**ALERT SERVICE BULLETIN**

**NO.** 230-01-20

**MODEL AFFECTED:** 230

**SUBJECT:** UPPER FUEL ENCLOSURE, RIGHT SIDE,  
ADDITION OF DRAIN PROVISION

FIGURE 1

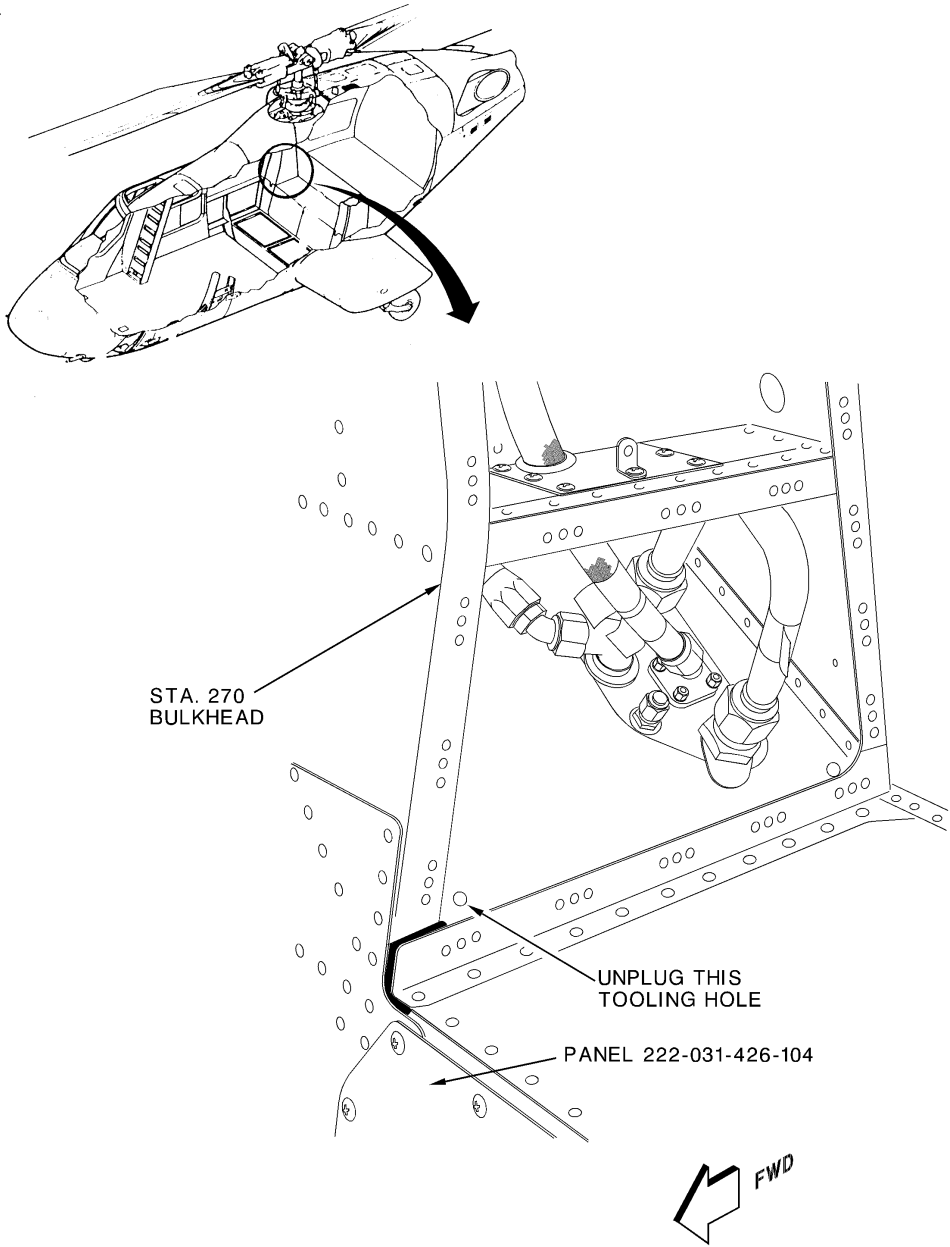
Bell Helicopter Textron has determined that a condition exists that could result in an accumulation of fuel or water in the right hand upper fuel enclosure area located at approximate STA 268.03 to STA 281.87 and W.L. 53.50.

This bulletin provides the procedures to remove the sealant from the existing forward tooling hole located in panel assembly P/N 222-031-470-103 to provide enclosure drainage provision.

Tooling hole is located at approximate STA 271.00, B.L. 22.25, W.L. 54.00 in panel assembly P/N 222-031-470-103

2. Remove fuel cell access panel P/N 222-031-426-104 located on the lower R/H side of STA 270 bulkhead. Refer to Figure 1 and refer to BHT-230-MM-5, chapter 53.

5. Locate forward tooling hole in panel assembly P/N 222-031-470-103 and unplug hole using a plastic scrapper and a pin punch or a similar object. Refer to Figure 1.
6. Reposition fuel cell upper right hand side into airframe cavity.
7. Install access panel P/N 222-031-426-104 with sealant MIL-S-8784CLB2. Refer to BHT-230-MM-5, chapter 53.
8. Install the seat cushions and seat backs on the rear passenger seats. Refer to BHT-230-MM-3, chapter 25.
9. Annotate helicopter records to reflect compliance with this bulletin.
